EXTRACT FROM COUNCIL MEETING MINUTES OF APRIL 19, 2016

DRAFT PLAN OF CONDOMINIUM (COMMON ELEMENTS)
FILE 19CDM-15V008
STATEVIEW HOMES (S COLLECTION) INC.
WARD 2 - VICINITY OF ISLINGTON AVENUE AND HARTMAN AVENUE

Re: PUBLIC HEARING – APRIL 5, 2016 – 7:00 PM
Draft Plan of Condominium (Common Elements); File 19CDM-15V008; P.2016.8
Stateview Homes (S. Collection) Inc. - Ward 2 - Vicinity of Islington Avenue and
Hartman Avenue

Draft Plan of Condominium File 19CDM-15V008 (Common Elements)

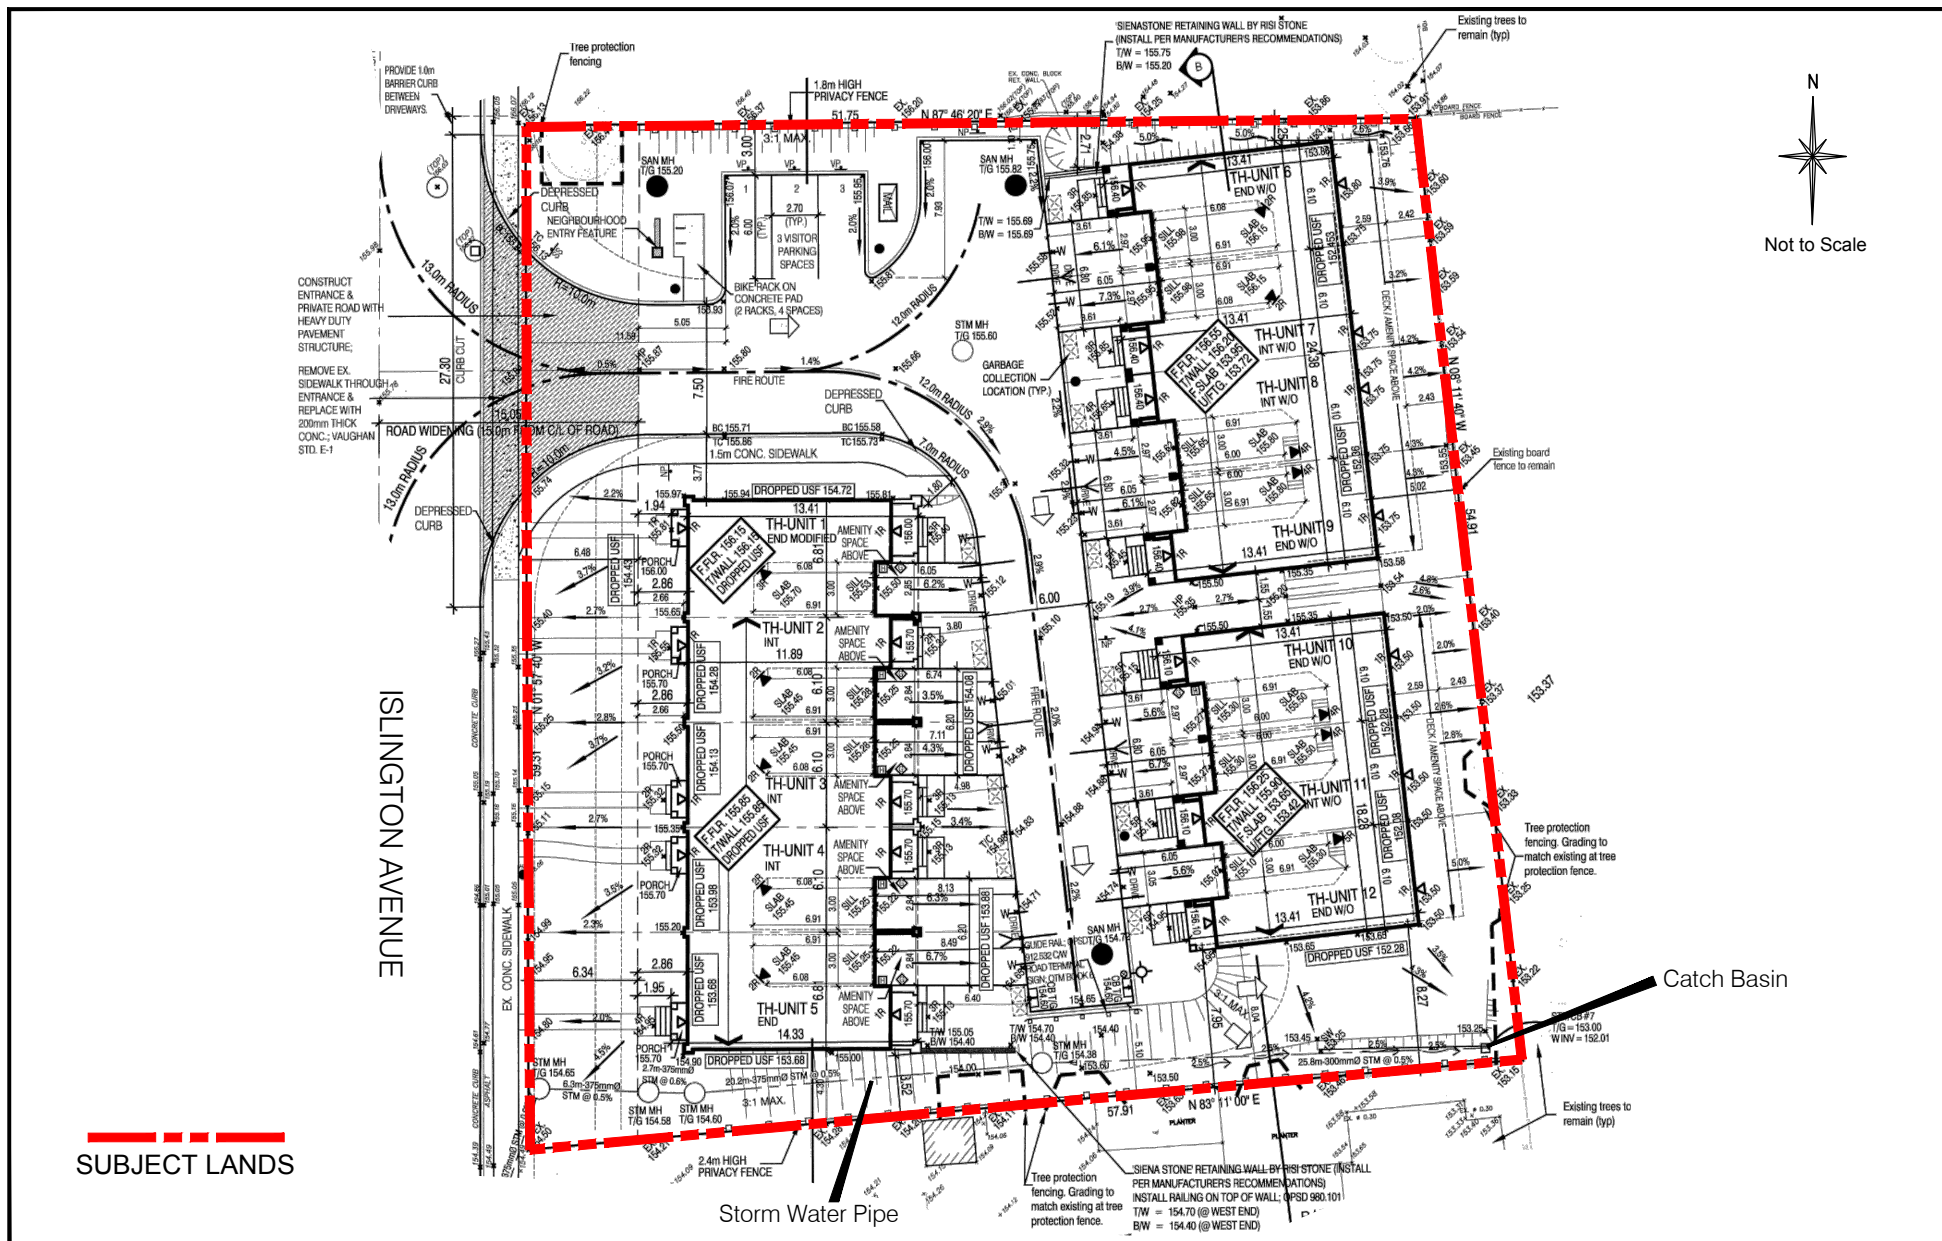
1. **Pipeline/catchbasin:** The report states that:
 - (a) a pipe located along the full length of the south property to convey storm water from a catch basin located at the southeast corner of the property to the storm water sewer on Islington Avenue as shown on Attachment #4.
 - (b) that "a small portion of this pipe would form a common element as it is located under the private road with the balance, including the catch basin, being located on the future lots identified as Parts 5 and 12 on Attachment #3, and the responsibility of the future lot Owners".
 - (c) that "The storm water pipe should form part of the common elements of the future condominium corporation. The appropriateness of the storm water pipe being part of both the private lots and the common elements will be reviewed."

The catch basin/storm water pipe is not only for the benefit of the future owners of Parts 5 and 12, but the catch basin/storm water pipe system is for the benefit of, for the most part, the future owners of Parts 6, 7, 8, 9, 10, 11 and 12, if not the whole subdivision, as the runoff from these other lots flow to the catch basin placed on the southeasterly lot to

catch all these flows. So why would you put this burden on the future owners of Parts 5 and 12 with a small portion only of the storm water pipe to be part of the common elements?

What happens if there is a backup/overflow from this catch basin and these future owners do not agree or are unable for whatever reason to deal with and fix the problem in a timely fashion? The result would be a flooding on their lands and to the lands of the adjoining land owners which would include and directly affect us, our property and our vegetation, what then? This could become quite a disastrous situation. We worked very hard for an excessive amount of time with the City of Vaughan staff in order to clarify the water flow for this property and to get a catch basin installed in order not to have flooding towards our property (adjoining lands to the south).

It is our opinion that it would not be appropriate to put the burden and onus of being responsible for the storm water pipe/catch basin onto the future owners of Parts 5 and 12, but the responsibility of the storm water pipe/catch basin system and whatever else is connected with this system to be of the Condominium Corporation and to be included in the Condominium Agreement and Condominium Declaration to make this part of the common elements. An Easement should be registered against the section of property where it is located on Parts 5 and 12 in favor of and form part of the condominium common elements in order to have access to maintain/repair etc. this storm water pipe/catch basin and whatever other connections that are included with this system.

1. **Pipeline/catchbasin:** The pipe runs the full length of the southerly lot line to convey storm water from a catch basin located at the southeast corner of the property to the storm water sewer on Islington Avenue. It is stated in this report that "a small portion of this pipe would form a common element as it is located under the private road with the balance, including the catch basin, being located on the future lots identified as Parts 5 and 12 on Attachment #3, and the responsibility of the future lot Owners".

A. The catch basin/pipe is not only for the benefit of the future owners of Parts 5 and 12, but the catch basin/pipe system is for the benefit of, for the most part, the future owners of Parts 6, 7, 8, 9, 10, 11 and 12, if not the whole subdivision, as the runoff from these other lots flow to the catch basin placed on the southeasterly lot to catch all these flows. So why would you put this burden on the future owners of Parts 5 and 12.

REQUEST: That the Condominium Corporation take sole responsibility and declare that the storm water pipe running along the full length of the southerly lot line from east to west and the catch basin system located on the southeasterly lot line be and form part of the common elements and these items be included in the Condominium Agreement and Condominium Declaration.
